**ARLINGTON COUNTY, VIRGINIA
OFFICE OF THE PURCHASING AGENT
INVITATION TO BID NO. 24-DES-ITBPW-397**

ADDENDUM NO. 2

Arlington County (hereinafter referred to as the "County") Invitation to Bid (ITB) No. 24-DES-ITBPW-397 for Stream Restoration is amended as follows:

PERIMETER WATERFOWL BARRIER FENCE
(NOT TO SCALE)

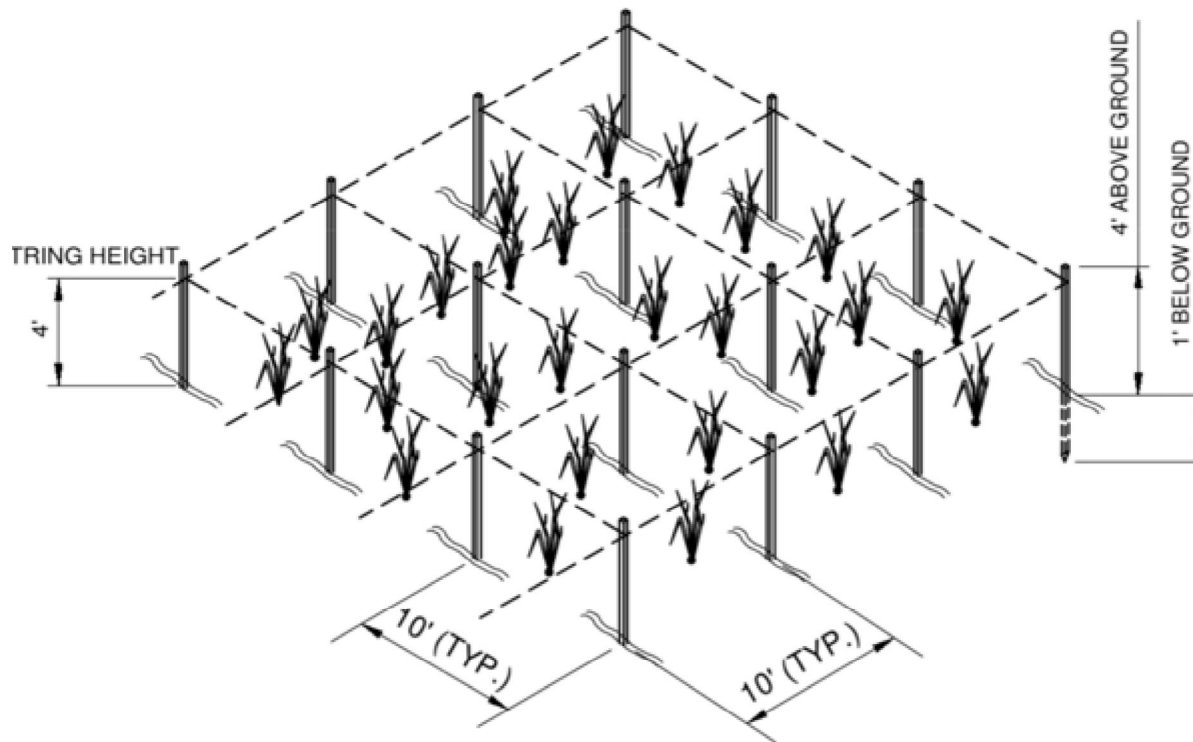
98	C11-43 Goose Fence Protection (installation) a. Are specifications available?	A goose fence detail is provided as an attachment to Addendum 2.
99	C11-44 Goose Fence Protection (Annual Maintenance) matting a. Please specify the "matting" required to complete this task. Or, is this a typo?	The word matting has been removed
100	C11-50 Soil Profile Rebuilding a. Are specifications available?	Please reference the specifications provided in the master ID column for all price list items. DES standard spec section 329100 should have descriptions

1. PERIMETER POSTS TO BE PLACED 10' APART. THE PERIMETER OF THE BARRIER CELL IS A 50'x50' SQUARE AS SHOWN IN THE DETAIL.
2. PERIMETER AND INTERNAL POSTS ARE 2"x2"x5' HARDWOOD POSTS. DO **NOT** USE PRESSURE TREATED WOOD.
3. INSTALL 4' HIGH PLASTIC FENCING ALONG PERIMETER POSTS. FENCE SHOULD HAVE A 1.75"x1.75" MESH GRID.
4. MOUNT NYLON STRING ATOP POSTS IN THE PATTERN INDICATED IN THE BARRIER CELL DETAIL.
5. TIE REFLECTIVE MYLAR FLAGGING BETWEEN POSTS.
